SUBJECT: Forwards response to NRC question on TS changes re suppression pool bypass leakage test & drywell-to-suppression chamber vacuum breaker leakage preliminary test strategy.

**SUSQUEHANNA STEAM ELECTRIC STATION
ADDITIONAL INFORMATION ON PROPOSED
AMENDMENTS 160 TO LICENSE NO. NPF-14
AND 113 TO LICENSE NO. NPF-22
PLA-4001 FILES A17-2/R41-2**

RESPONSE TO NRC QUESTION ON TECHNICAL SPECIFICATION (TS) CHANGE
SUPPRESSION POOL BYPASS LEAKAGE TEST

**DRYWELL-TO-SUPPRESSION CHAMBER VACUUM BREAKER LEAKAGE
PRELIMINARY TEST STRATEGY**

Typical Test Sketch using Flowrate Makeup Method

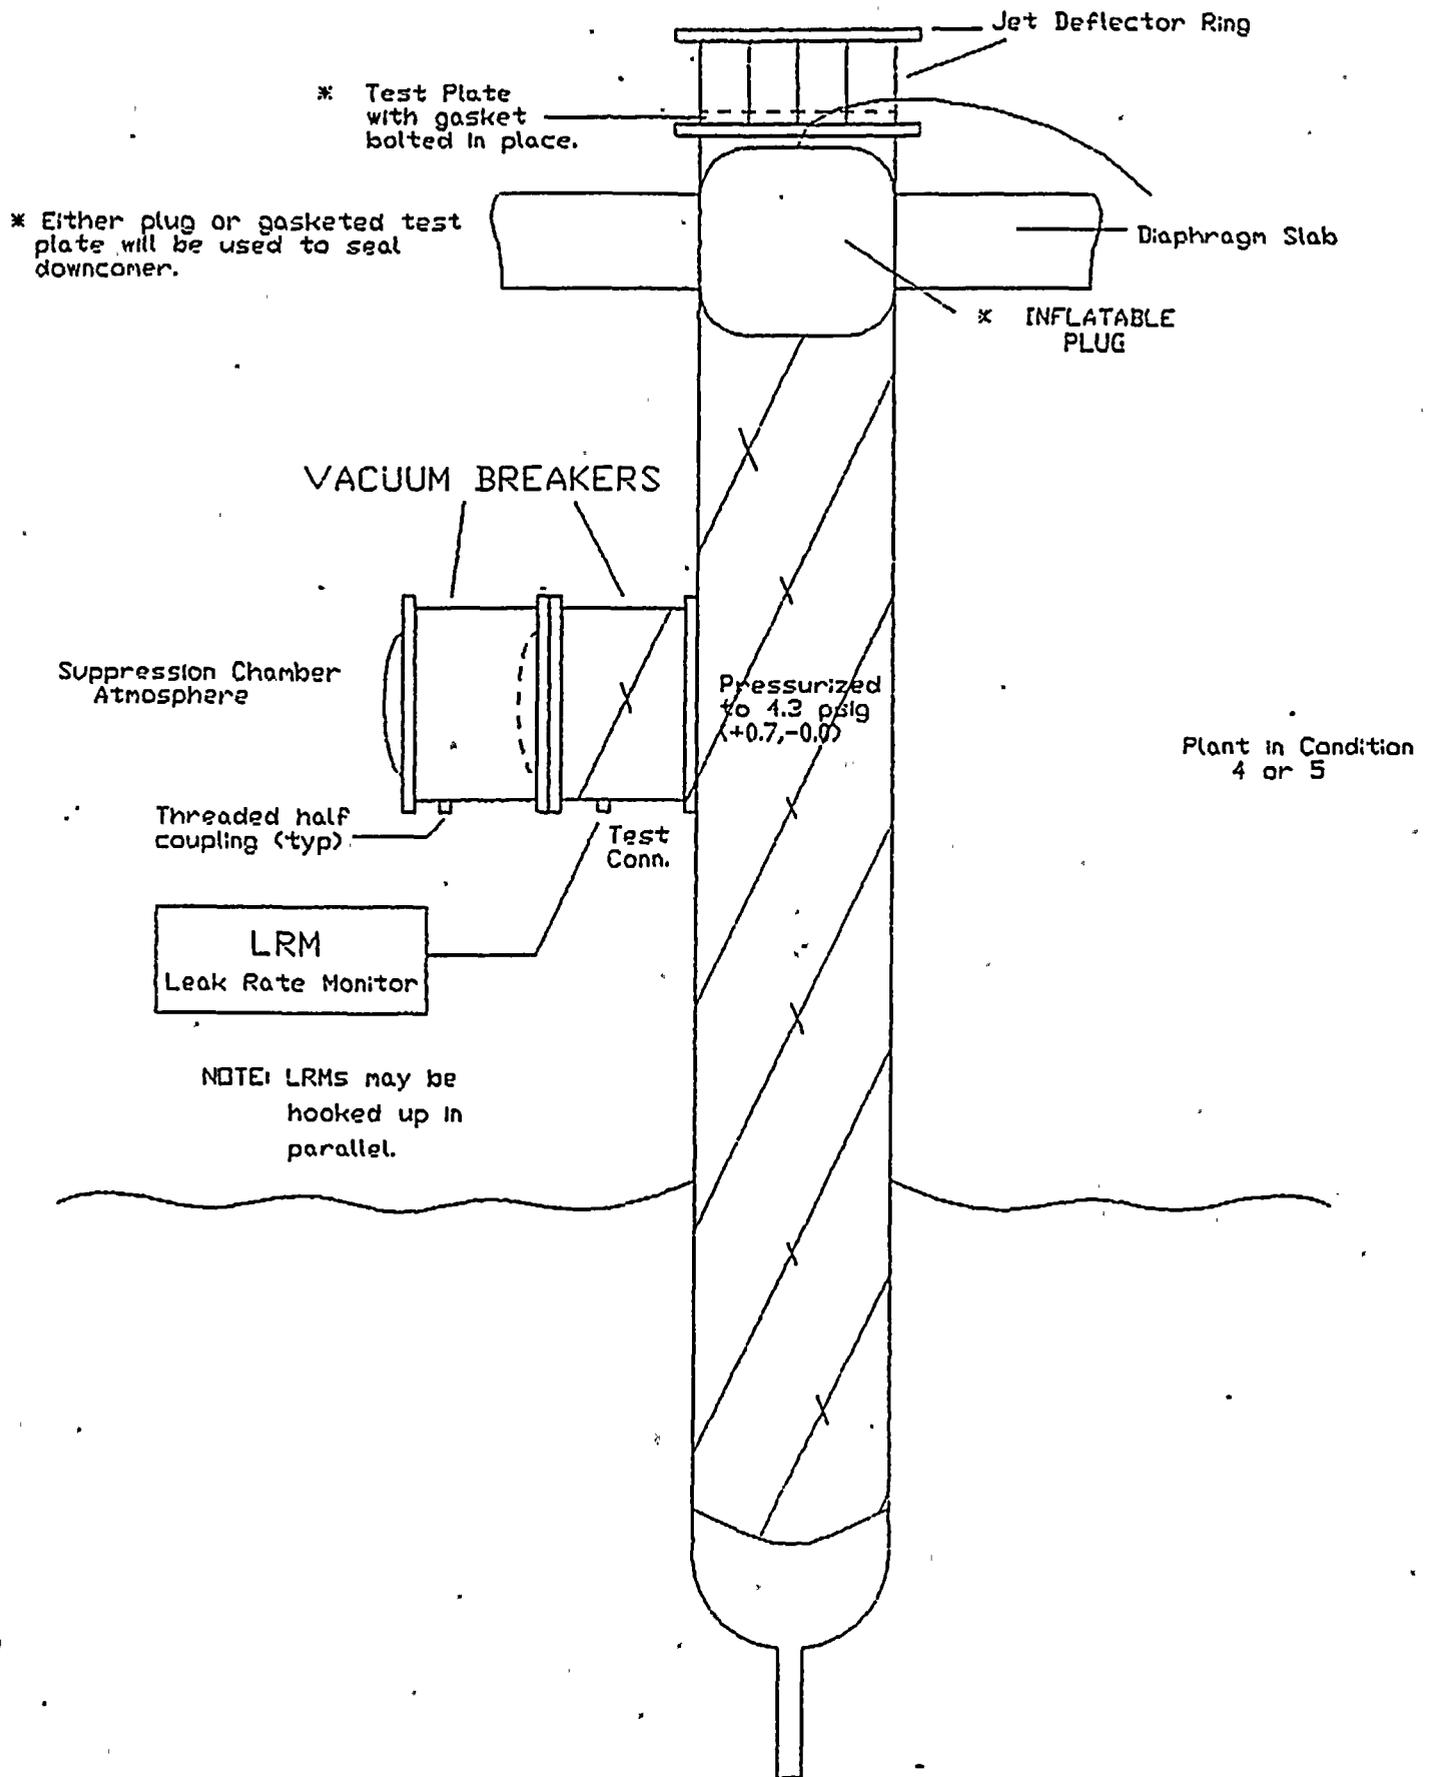
The preliminary leakage testing strategy associated with the technical specification change for drywell-to-suppression chamber vacuum breaker leakage is as follows and is shown on the attached sketch:

- The plant will be in condition 4 or 5.
- Maintenance and any other surveillance testing will have been completed prior to testing a set of vacuum breakers.

- The drywell side of the downcomer will be blanked off with either a gasketed test plate or an inflatable plug. The test plate is permanent plant equipment and is contained within the the jet deflector ring.

- Vacuum breakers will be closed by normal means; all half couplings will be plugged except the test connection.
- A leak rate monitor (LRM) will be attached to a threaded half coupling on the inboard vacuum breaker. This will permit pressurizing the test volume via the half coupling to 4.3 psig (+0.7, -0.0).

- After the volume has stabilized the makeup flow (leakage) into the test volume will be read directly from the LRM.
- If the measured leakage exceeds the capability of the LRM, additional LRMs will be hooked up in parallel and the total leakage will be the sum of all the LRM readings.

- The leak rate will be compared to the technical specification acceptance criteria.
